REPORT DOCUMENTATION PAGE		READ INSTRUCTIONS BEFORE COMPLETING FORM
1. REPORT NUMBER	2. GOVT ACCESSION NO.	3. RECIPIENT'S CATALOG NUMBER
4. TITLE (and Subtitle) A PRELIMINARY HUMAN ENGINEERING EVALUATION OF HYPERBARIC CONTROL SYSTEMS.		5. TYPE OF REPORT & PERIOD COVERED Medical Research Progress Report.

**A PRELIMINARY HUMAN ENGINEERING EVALUATION
OF HYPERBARIC CONTROL SYSTEMS**

The information to be reported emanates from a preliminary evaluation dealing with human factors design adequacy of hyperbaric control/displays developed for the hyperbaric research facility. Although the control-panel designs had been approved and fabrication was underway, a preliminary review of the engineering diagrams for the control panel revealed that the existing designs might contribute significantly to decrements in overall system performance: a thorough human factors engineering analysis appeared to be required. The scope of this report is limited to an analysis of the instrumentation/man interface.

Fig. 9. Gas control farm #3007875 exemplifies a situation where components are susceptible to operator impact and poor visual access.

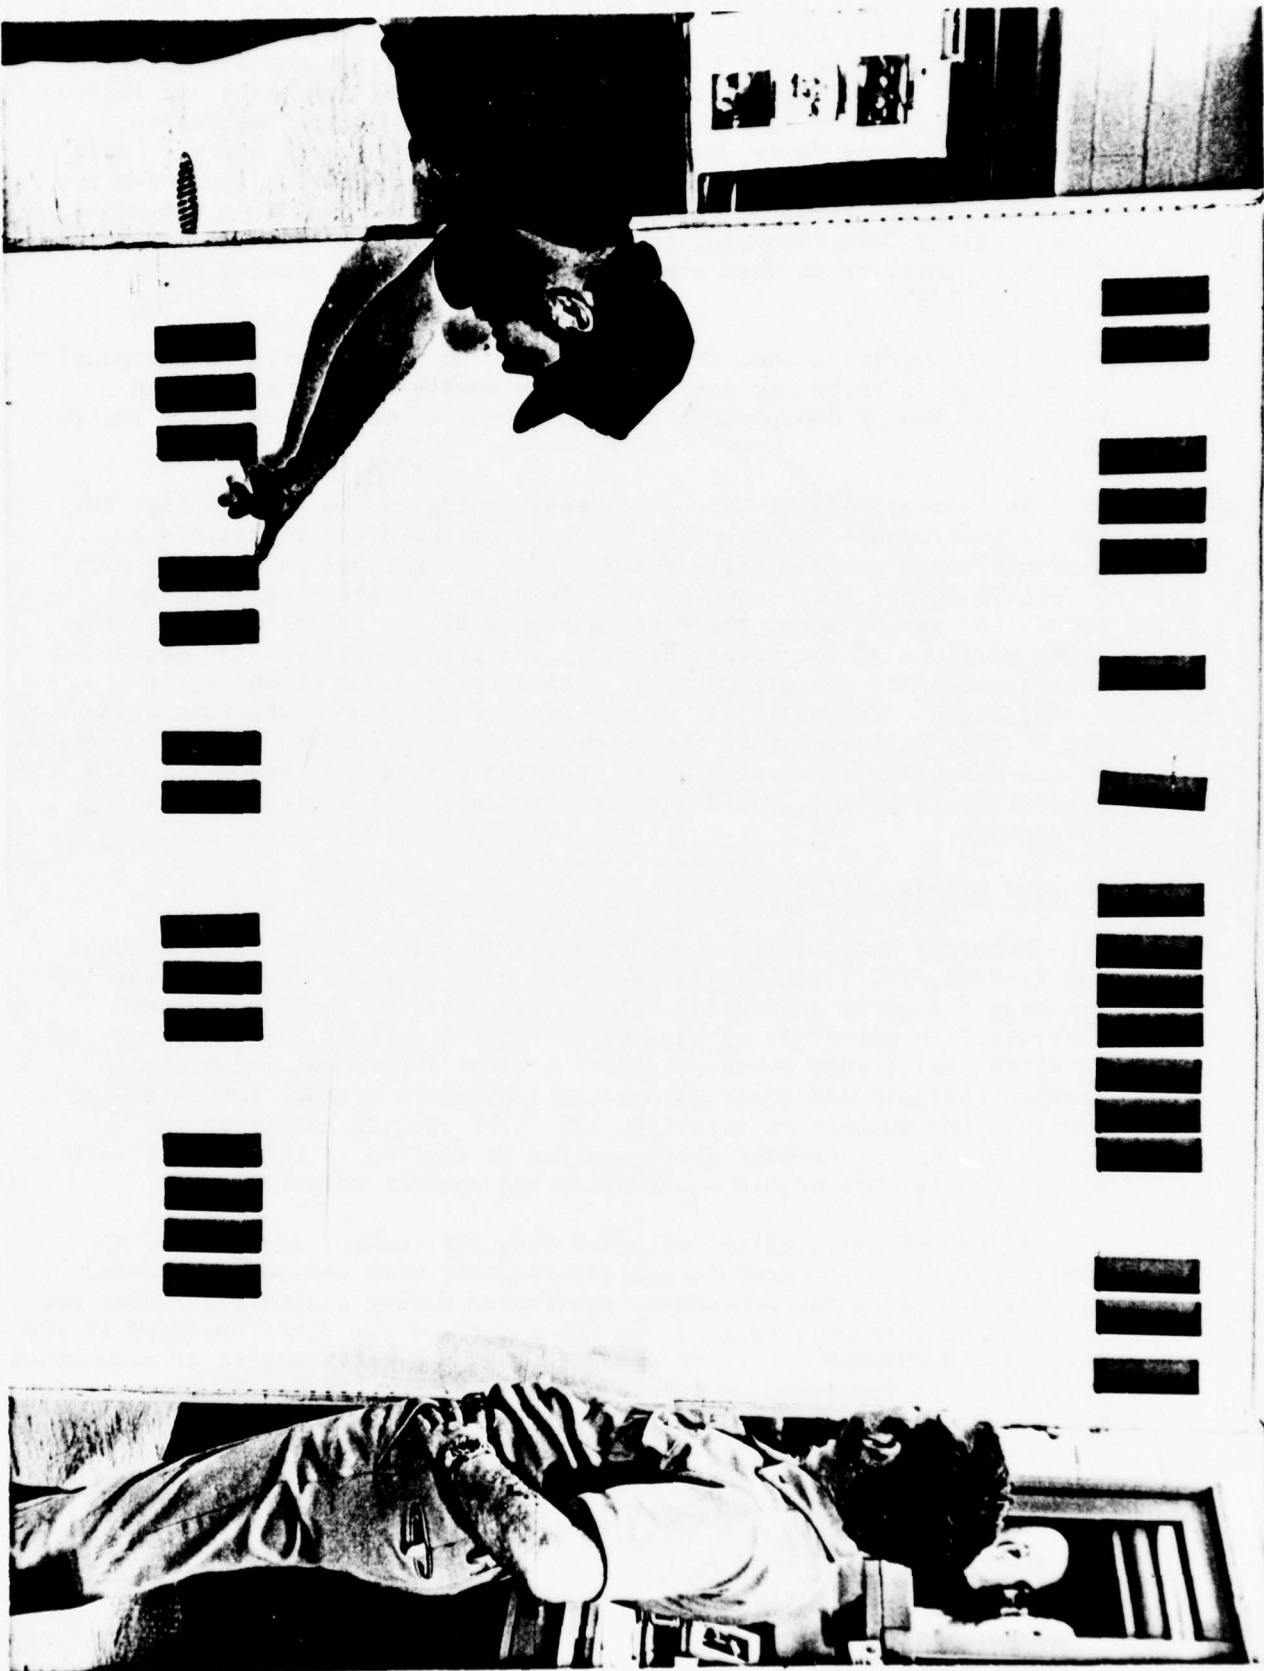
Tests were conducted to learn whether the hyperbaric gas-storage panel (Fig. 9) could meet this requirement and whether it would allow operators to locate information quickly without excess bodily motion (bending, turning, etc.). Figure 9 offers a photographic frontal view of this panel. Note that the indicator components at the bottom of the panel are 12 inches from the deck. The results of our tests are inadequate at the present time, because we did not have information needed to construct the dial faces, numbers, and scales. We were, however, able to determine that direct visual access to the information presented via these components required operators either to back away from the panel by at least 2 feet (assuming the operator is normally standing 12 inches from the panel) or to bend over to a point where the viewing angle is less than 125°.

It is suggested that these components be moved upward on the panel by at least 21 inches to decrease the present viewing angle and to reduce the amount of operator movement required to examine these instruments.

Fig. 10. The large, round pressure meters are located too high on the control panel for optimizing the operator's viewing field. (The human operator is 5 ft 10 inches tall.)

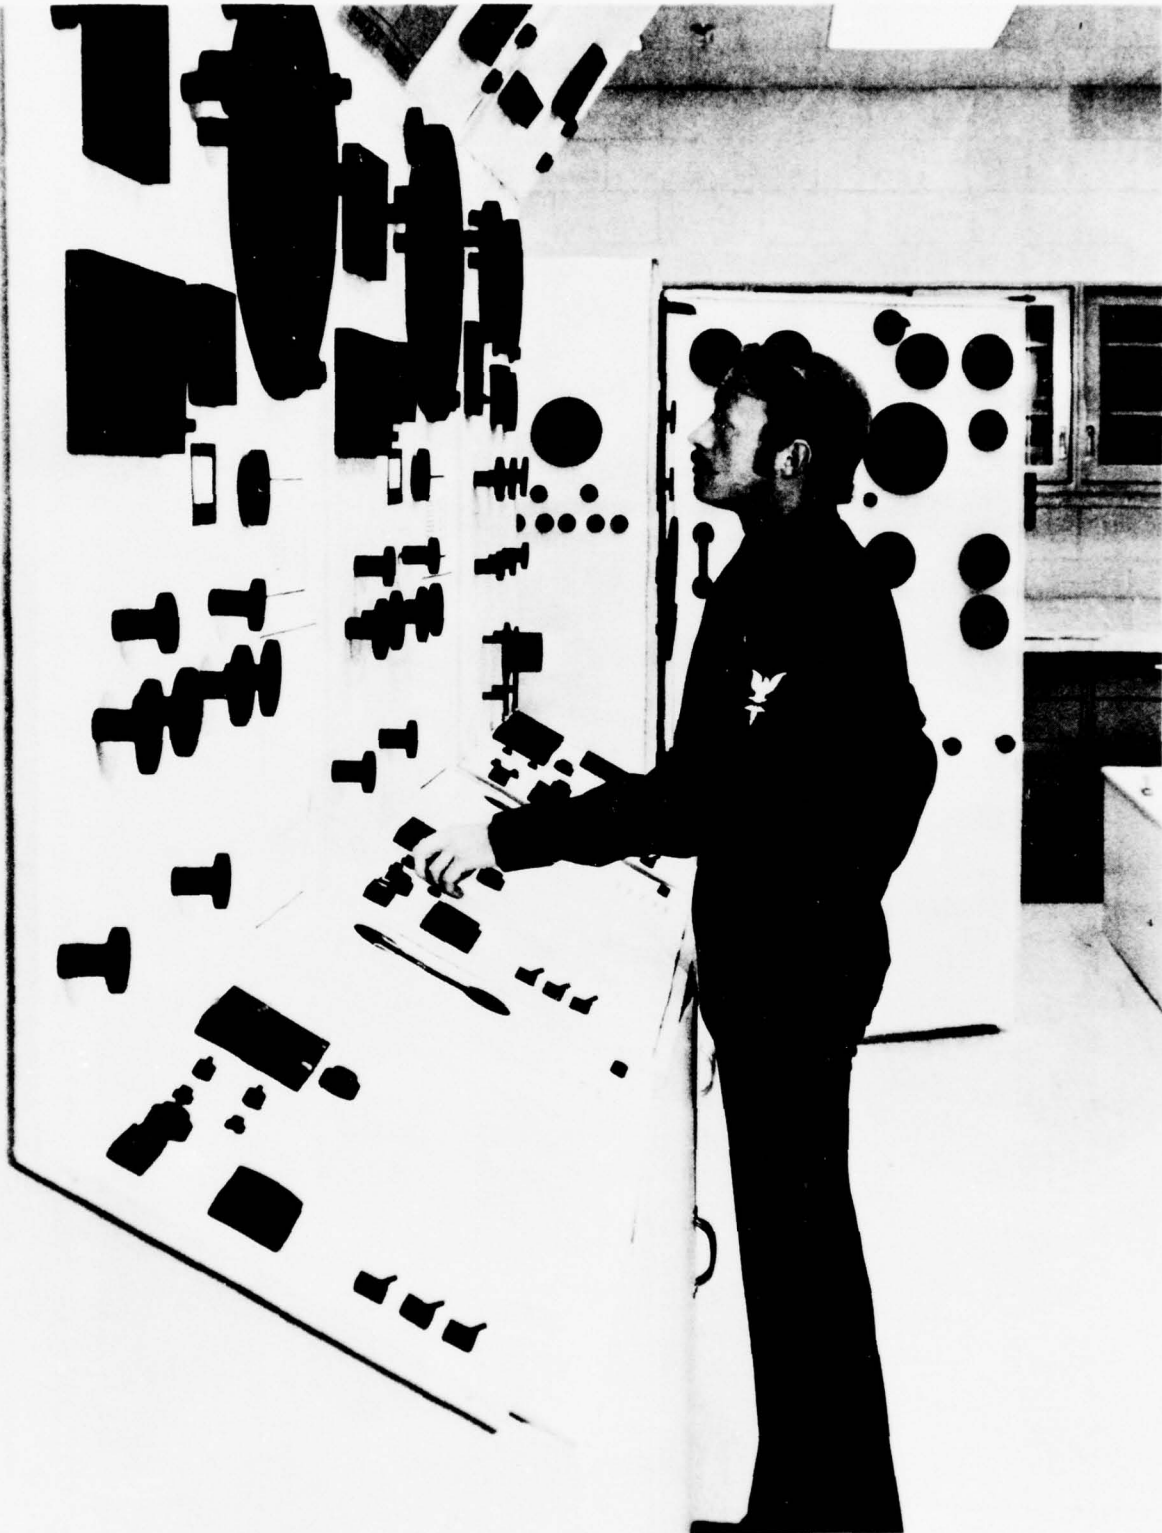
Another example of suboptimal positioning can be seen in Fig. 10. The large, round, circular disk in front of the diver represents a pressure/depth gauge meter. The diver in the picture is slightly over 5 feet 10 inches tall (65th percentile-height, Beatty and Berghage, 1972). As can be seen, the diver has good direct visual access to the lower portions of the meter, however, the greater part of the meter, representing mid-range depths, is clearly placed out of the optimal visual angle. Virtually all of the experienced divers who were given check lists indicated that the meter should be placed in a lower position on the console. The seated diver, and those that fall below the 50th percentile in height, would have an especially difficult time reading this gauge.

Fig. 11. Side panel local #3007874 is used for sanitary draining. Control/indicator relationships are vague.

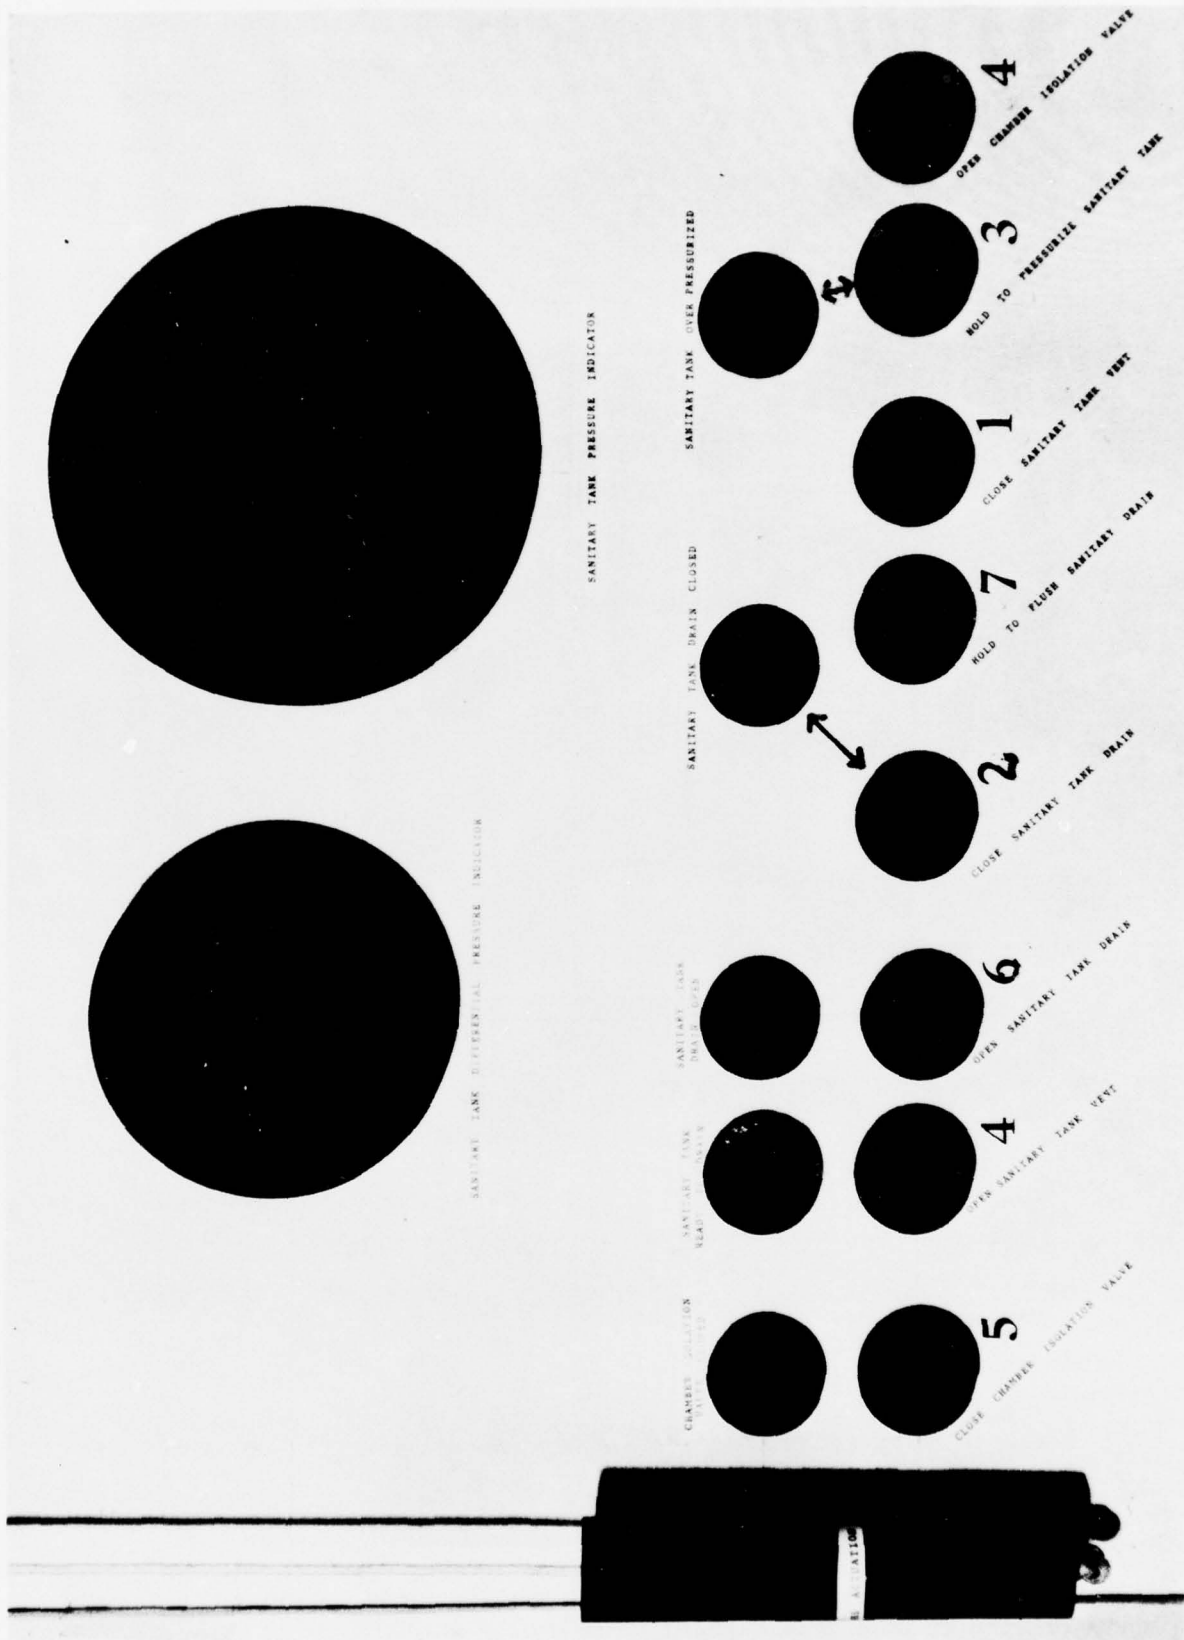
An additional finding indicated that the control sequence of the sanitary draining components was inconsistent with defined procedural operation. Since the procedures instituted during sanitary draining are known to be extremely critical to the safety of the diver enclosed in the pressurized chamber, it is recommended that a greater degree of sequential compatibility be incorporated into the panel design. Figure 11 displays the side of the local panel that contains the sanitary draining controls. Note the

numbers located just below each control button. The numbers represent the sequence of control actions employed during a sanitary draining procedure. It would be far better for an operator to move through this sequence in a smooth left-to-right direction. This could be accomplished by placing the sanitary-tank vent close control on the far left, followed by the sanitary-tank drain close control, pressurization control, and so on, until finally control #7 would be placed on the far right of the panel, at the position now labeled #4.

The arrows in Fig. 11 are pointing toward control lights and their associated activation buttons. Notice that two of the lights are not aligned with the appropriate activation button. These existing relationships between control and display should be made more explicit. It is further recommended that controls associated with valve-closing procedures be clearly distinguished from those controlling valve openings. The reasoning for this recommendation is obvious when one considers the consequence of inadvertently opening a low-pressure line when the sanitary tank is under pressure.

Fig. 12. The relative position of the fire emergency lanyard is shown. Note its proximity to the working environment.

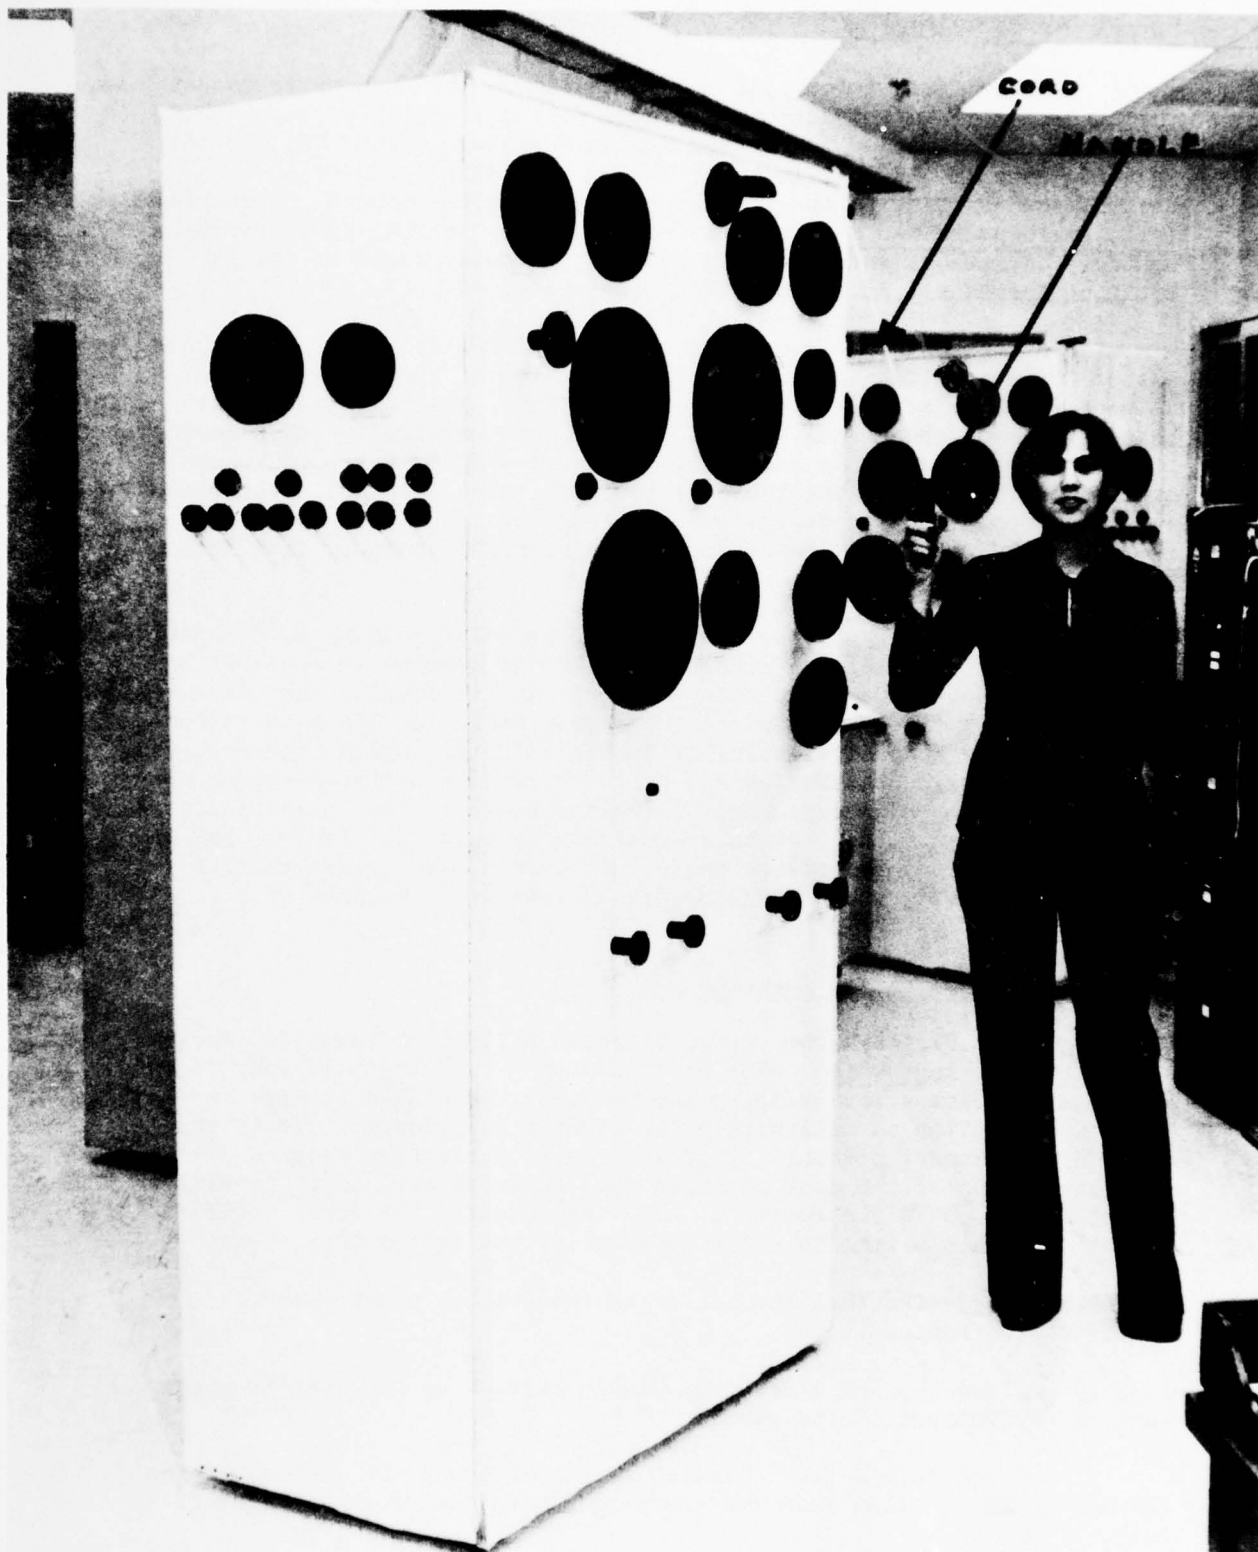
Figure 12 displays the fire-extinguish activation lanyard. The fire-extinguishing system (FES) is activated by pulling this lanyard in a downward motion after grasping the handle. The handle is free to swing and is situated well within the working environment. It is thus exposed to a higher probability of accidental activation because of the swinging motion of the cord to which the handle is attached. It will be important for us in the future to have knowledge of the force required to activate this system in order to address this system more adequately.

We make these recommendations because seven of the eight divers tested considered the current configuration undesirable. Furthermore, human factors engineering guidelines (VanCott and Kinkade, 1972) stress that accidental activation of emergency equipment should be reduced to an absolute minimum.

1. Place the FES activation handle further up and away from the working environment of the panel.
2. Substitute a fixed-handle, single-motion lever instead of the lanyard so as to allow easy emergency operation and prevent accidental activation.

3. Locate the FES actuation arm at the front-top of the panel and clearly mark it.

Fig. 13. Example of poor task-loading decision.

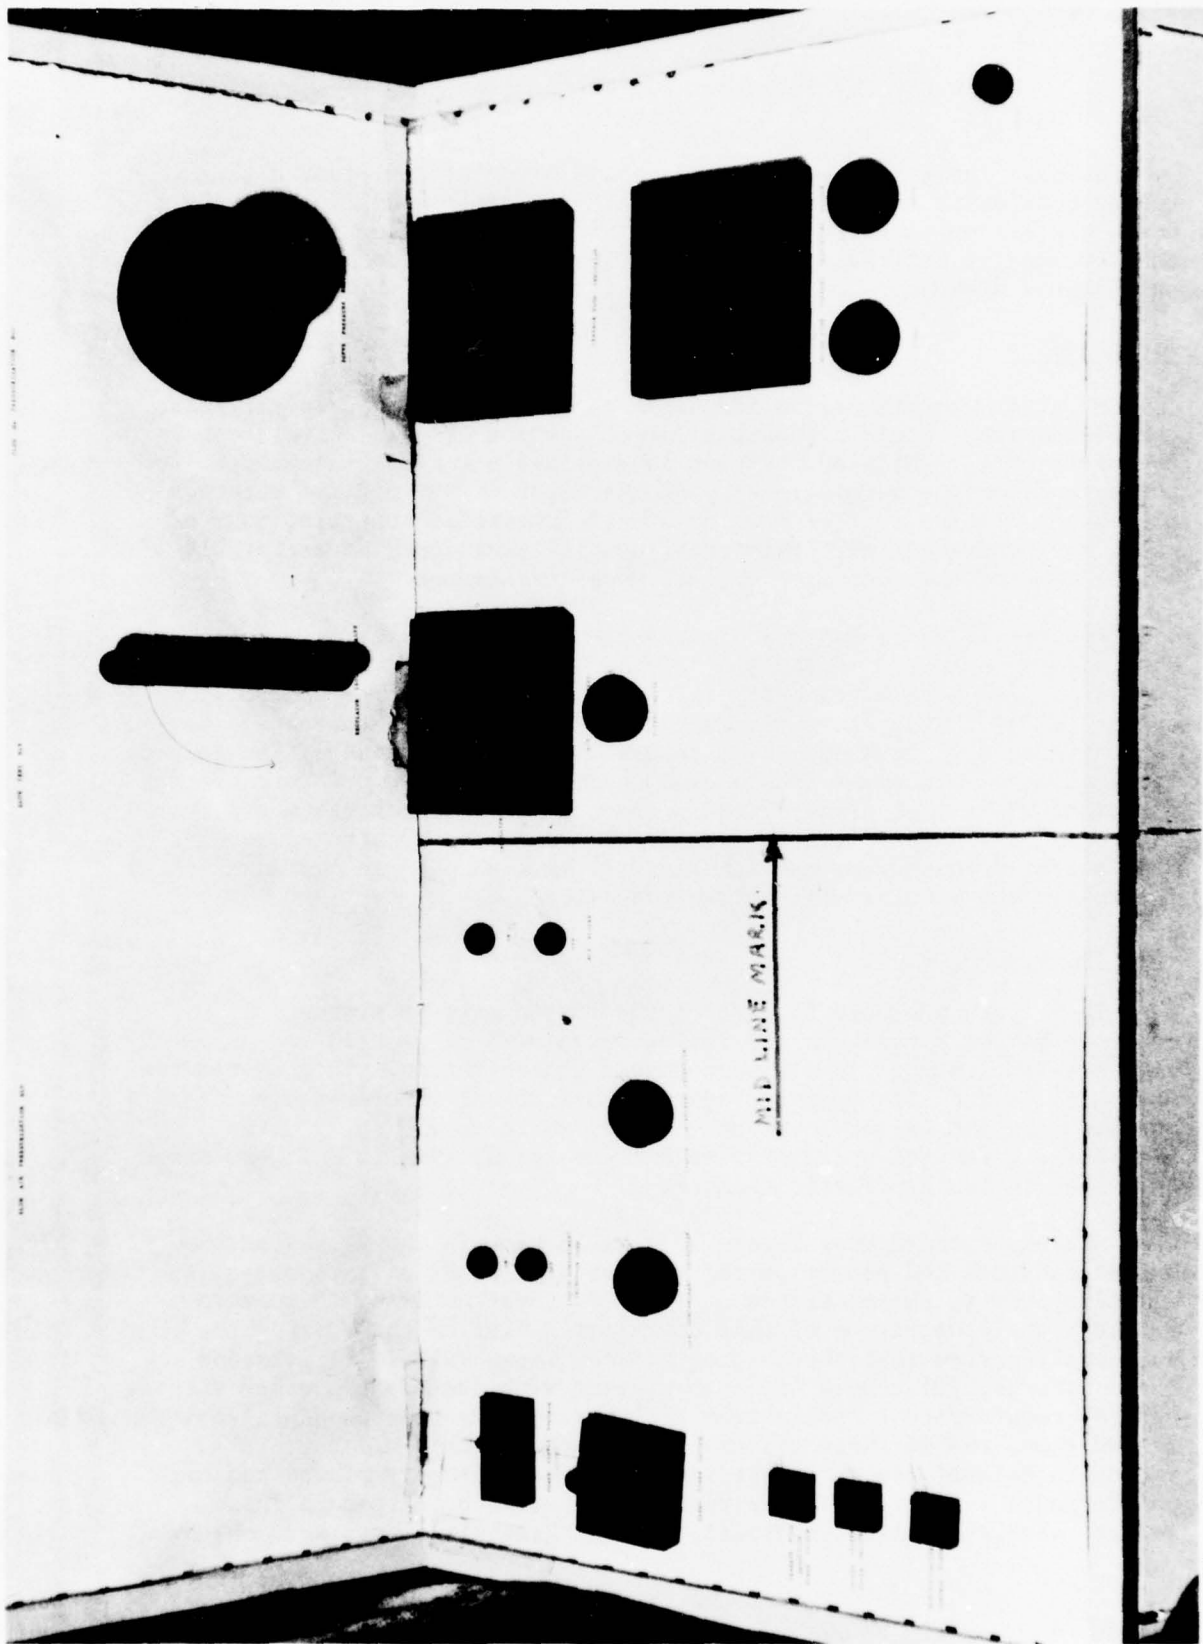
Military specifications for human engineering designs specify that console designs should allocate a larger portion of the control task to the operator's right hand. Figure 13 displays a control panel with three functional controls located to the right of the midline mark on the panel. To the left of midline are 11 functional controls, most of which are power-related. This configuration would only be acceptable if all or most of the control operators were left-handed.
